SERVICE BULLETIN

APPLICABILITY: 2015-2018MY WRX and WRX STI Models **NUMBER:** 12-243-18
SUBJECT: Paint Chipping between Hood Grille (Scoop) and Hood **DATE:** 06/06/18

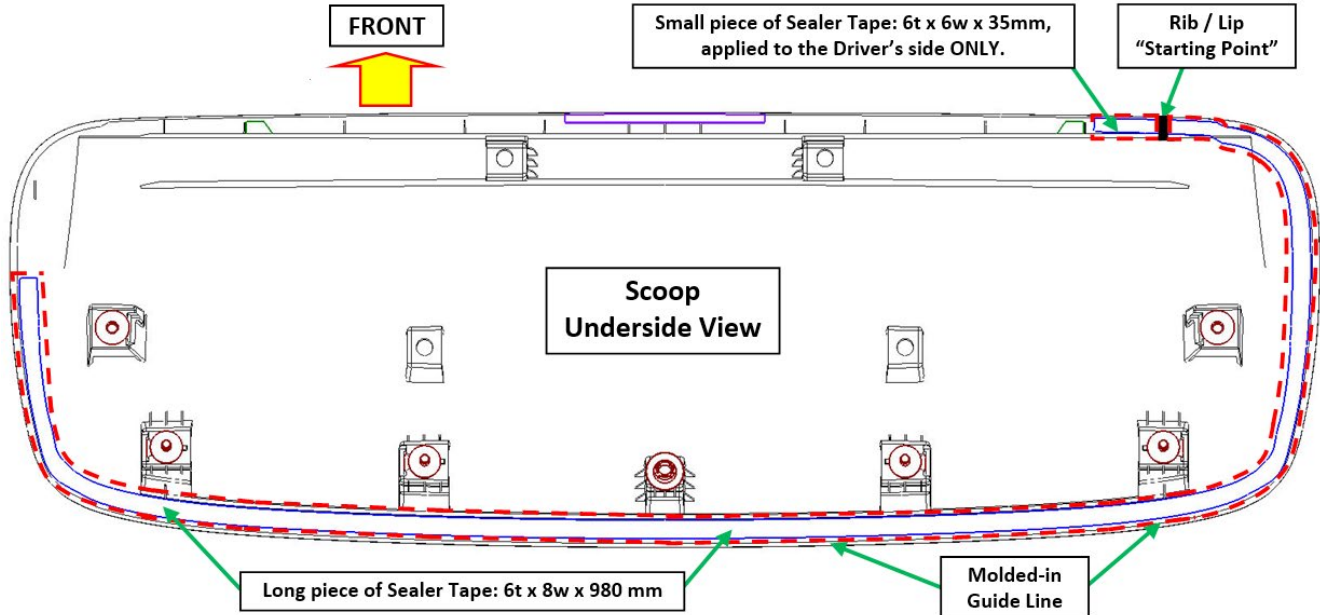
This bulletin replaces TSB **12-201-16R** and provides a new repair procedure to address customer concerns of the hood scoop scrubbing the finish of the hood panel in the areas shown in the photo below. Due to different expansion rates between the metal hood panel and the resin material used for the hood scoop, the edges of the scoop's rear corners may come in contact with the hood panel and abrade the finish.

The procedure involves installation of a new hood scoop assembly which includes re-designed Sealer Tapes to eliminate contact between the scoop and hood panel.

1. **CAREFULLY** remove the inner hood duct and scoop following the procedure in the applicable Service Manual.
2. Repair any abraded paint on the hood using touch-up paint. If the damage is too severe for the use of touch-up paint, a body shop spot repair may be necessary. If it is believed any more involved repairs are required, consult your DPSM **before** proceeding.

3. Identify the molded-in part number of the scoop currently installed:
 - If the part number is 90821VA000 or 90821VA002NN (the part number may or may not be molded into the part), replace it with the new part number 90829VA010NN.

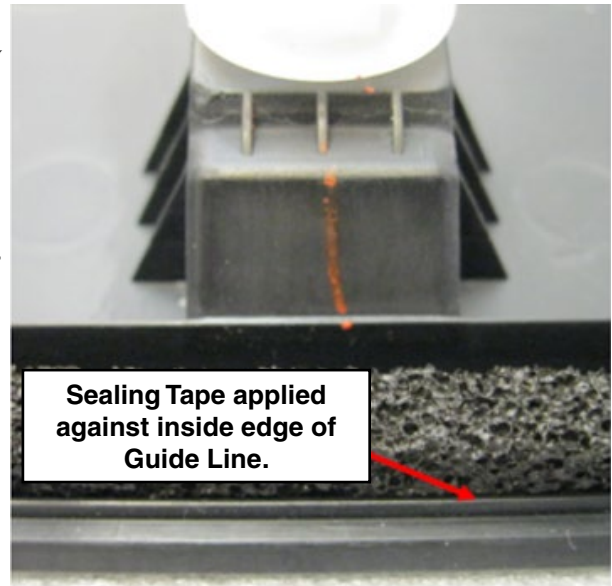
6. A close inspection of the underside perimeter will reveal a molded-in Guide Line to identify where the Sealing Tapes are to be positioned when applied. Use this photo as a reference to show how the completed tape installation should appear. **CAREFULLY** peel the backing and beginning at the “Starting Point”, apply the Sealing Tape **INSIDE** the Guide Line. Be careful not to stretch the tape while applying it.

TIP: To make the Sealing Tape more manageable, peel the backing as the tape is applied.
